OICA comments on GTR22 Annex 2
EVE-IWG #63
18.-19.07.2023

Annex 2

coming from EVE-46-03e

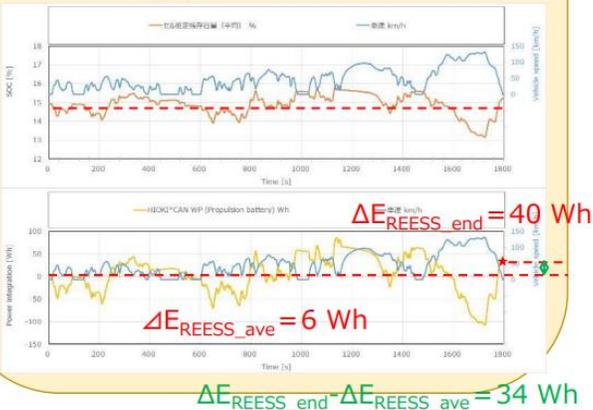
correction of UBE via average energy from conformation cycle

to calculate the **average energy**, an average of the **energy curve** is needed

currently version of GTR22 annex 3 3.1.1. shows this formula:

outer integral is calculating the **average** of inner integral

but **inner integral does not calculate** an **energy curve** $E(t)$, it calculates the energy change between start and end of Confirmation cycle, which is a constant.

This is **due to upper bound** of the **inner integral** $t_{end,CC}$

to get the **energy curve** and be able to calculate $\Delta E_{REESS,avg}$ as intended a possible solution could be to change the upper bound:

$$\Delta E_{REESS,avg,i,cc} = \frac{1}{3600} \times \frac{1}{t_{end,cc} - t_{start,cc}} \times \int_{t_{start,cc}}^{t_{end,cc}} \int_{t_{start,cc}}^t U_{REESS,i}(t) \times I_{REESS,i}(t) dt dt$$
